Access Compliance Report

Public Rights-of-Way

(Curb Ramps)

Intersection ID: 42368	Main Street: FAIRVISTA_DR	Cross Street: HIGHLAND_CREEK_PY	Location: S
ADA ID: 7AD79EA44490	Ramp Type: PerpDiag	Initial Pass/Fail: Fail	Overall Compliance: No
		Severity Score: 12.5

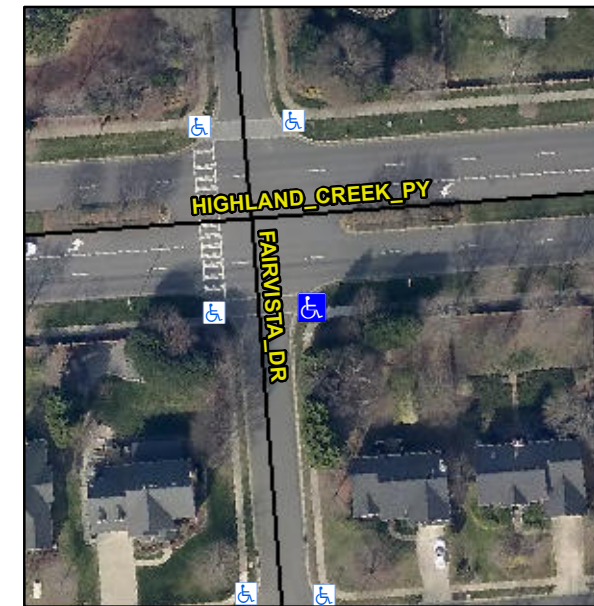
Not Found, R304.5.3

Compliance	Description	Data	Compliance	Description	Data
N/A	Ramp Length (in)	92.0	Yes	Ramp Slope (%)	8.1
Yes	Ramp Width (in)	48.0	No	Ramp XSlope (%)	5.2
N/A	Flare Type LT	N/A	N/A	Flare Type RT	N/A
N/A	Flare Slope LT (%)	N/A	N/A	Flare Slope RT (%)	N/A
N/A	Flare Traversable LT?	N/A	N/A	Flare Traversable RT?	N/A
N/A	Landing Length (in)	N/A	N/A	DWS Provided?	N/A
N/A	Landing Width (in)	N/A	N/A	DWS Contrast?	N/A
N/A	Landing Slope (%)	N/A	N/A	DWS Length (in)	N/A
N/A	Landing X Slope (%)	N/A	N/A	DWS Full Width?	N/A
N/A	Landing Curb? (Y/N)	N/A	N/A	DWS Offset (in)	N/A
N/A	Shared Landing?	N/A			
N/A	Gutter Ponding?	N/A	N/A	Gutter Slope (%)	N/A
N/A	Gutter Lip Ht (in)	1.0	N/A	Gutter X Slope (%)	N/A
N/A	Painted X Walk1?	No	N/A	Painted X Walk2?	No
	X Walk 1 Direction	To N		X Walk 2 Direction	To W
N/A	X Walk 1 Width (in)	N/A	N/A	X Walk 2 Width (in)	N/A
	X Walk 1 Slope (%)	4.1		X Walk 2 Slope (%)	0.9
	X Walk 1 X Slope (%)	1.2		X Walk 2 X Slope (%)	5.9

Remove & Replace Curb Ramp With Two New Directional Ramps or Equivalent.
